**ADDENDUM No. 4**

**CITY OF DELANO**  
**WELL 41 EQUIPPING PROJECT**

August 14, 2019

# WROUGHT IRON SLIDE GATE DETAIL

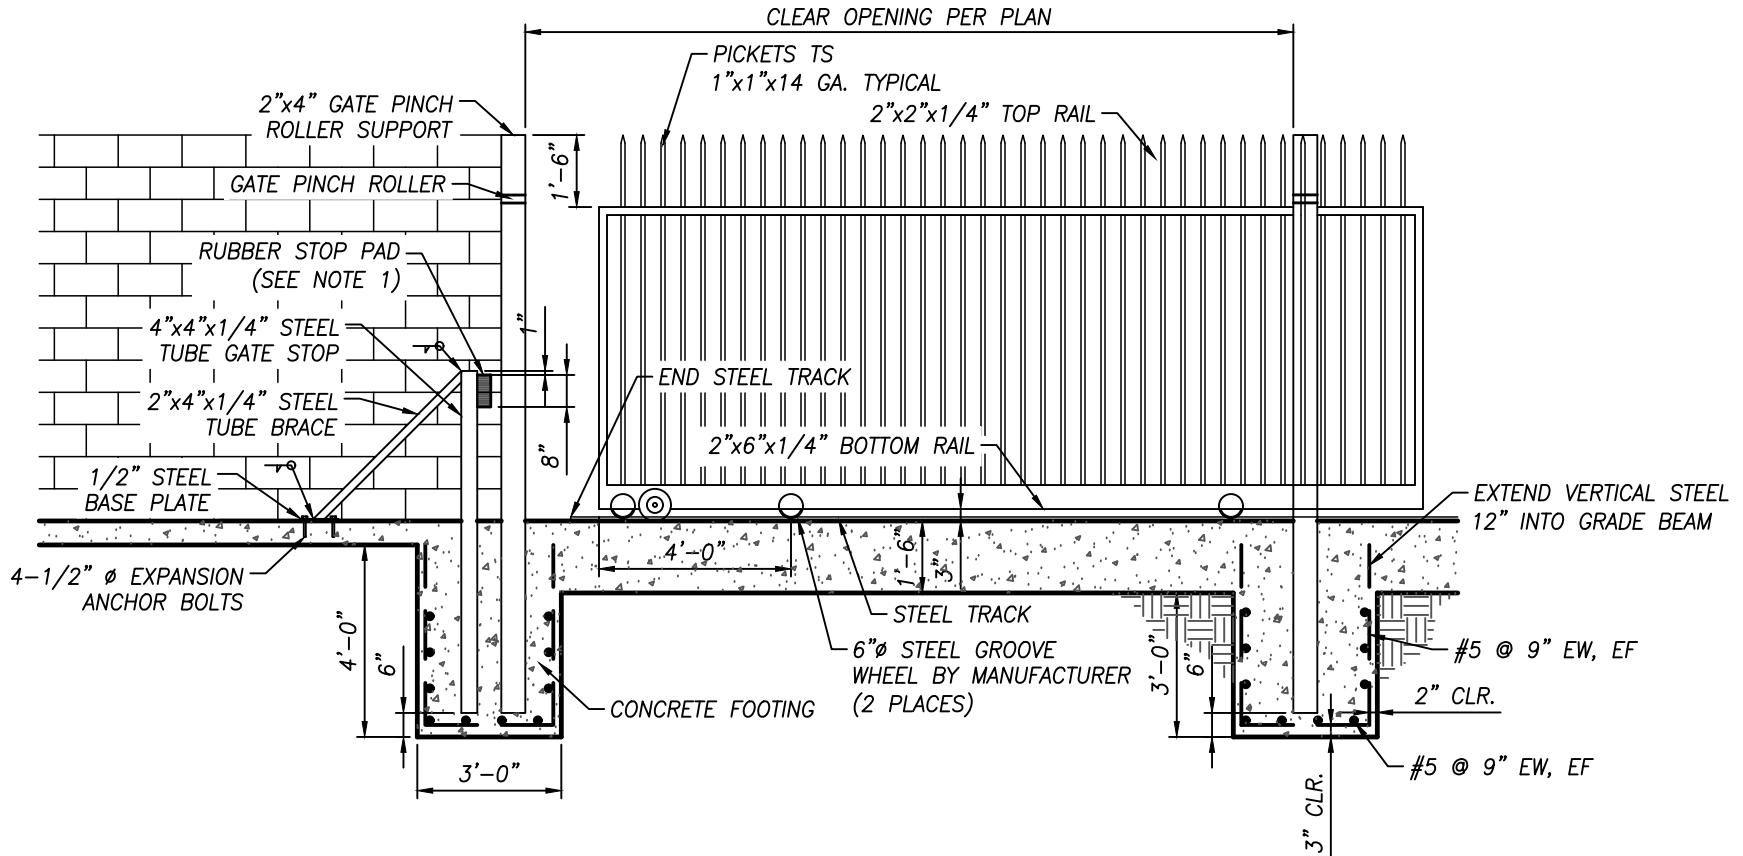
**Item 1.** Add wrought iron slide gate detail, attached.
